UNITED STATES PATENT AND TRADEMARK OFFICE

APPLICATION NO.	FILING DATE	FIRST NAMED INVENTOR	ATTORNEY DOCKET NO.	CONFIRMATION NO.
09/992,591	11/06/2001	Paul R. Margiott	C-2451	7404

Office Action Summary

The present application is directed to a procedure for shutting down a fuel cell and fuel processing system.

FIG. 1

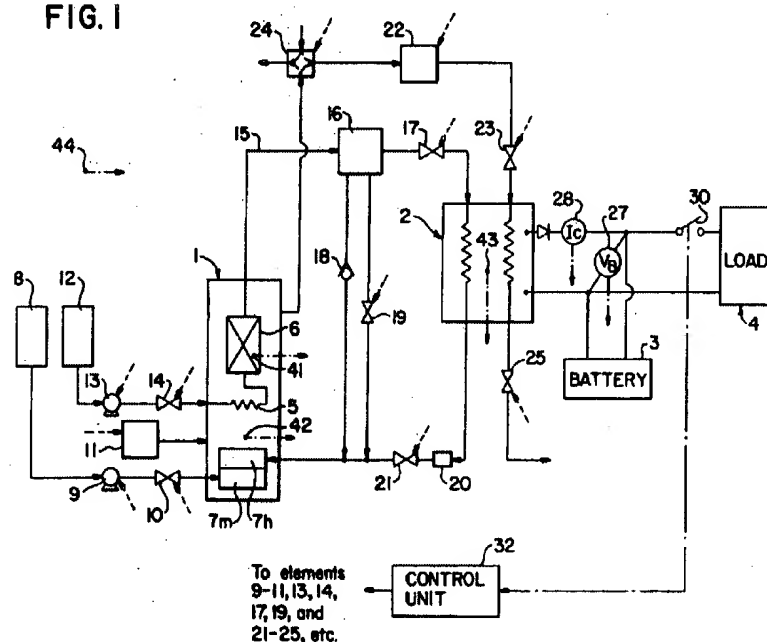
Figure 1 below illustrates the fuel cell processor 1 for generating hydrogen. Connected in parallel to fuel cell 2 is a storage battery 3. A load 4 is connected to both fuel cell 2 and the battery 3 (COL 2, lines 23-31). A fuel tank 8 storing methanol fuel for the burner 7m where it is burned with the aid of air supplied (COL 2, lines 40-48). 7M and 7H also represent burners (COL 2, lines 37-39).

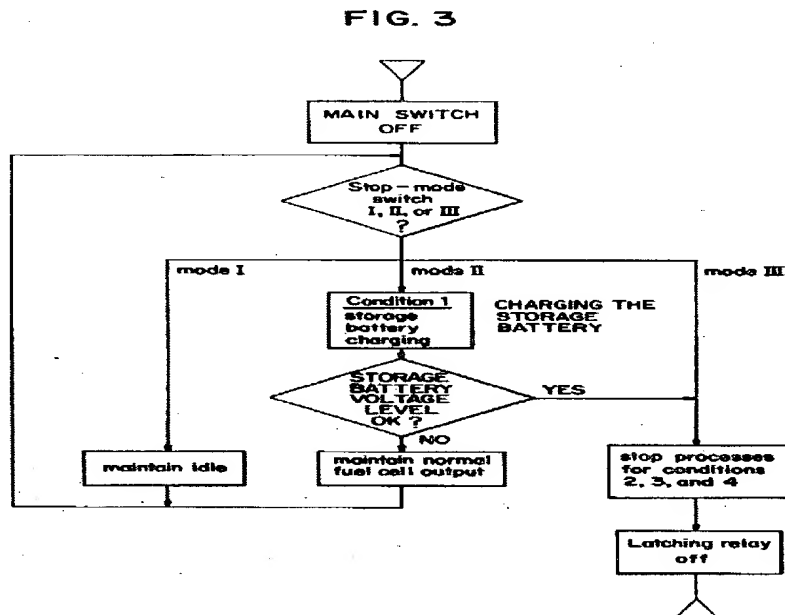
Figure 3 below depicts the shut-down method for a fuel cell system:

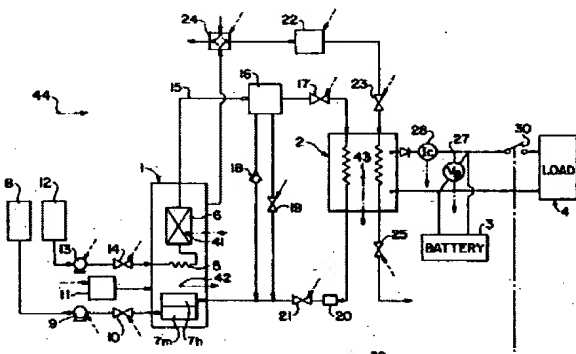
Figure 1 and its enlarged section below shows the fuel cell structure. *It is noted that the top and bottom part of feature 2 represents the two fuel cell ends.* It is also disclosed heating burners 7M and 7H making hot gases (COL 2, lines 35-45). *These burners are in fluid communication with the fuel cell 2.* It is also disclosed that valve 24 is connected thereto, allowing the selection of either low temperature atmospheric air or high temperature air from fuel processor 1 (COL 2, lines 62-67).
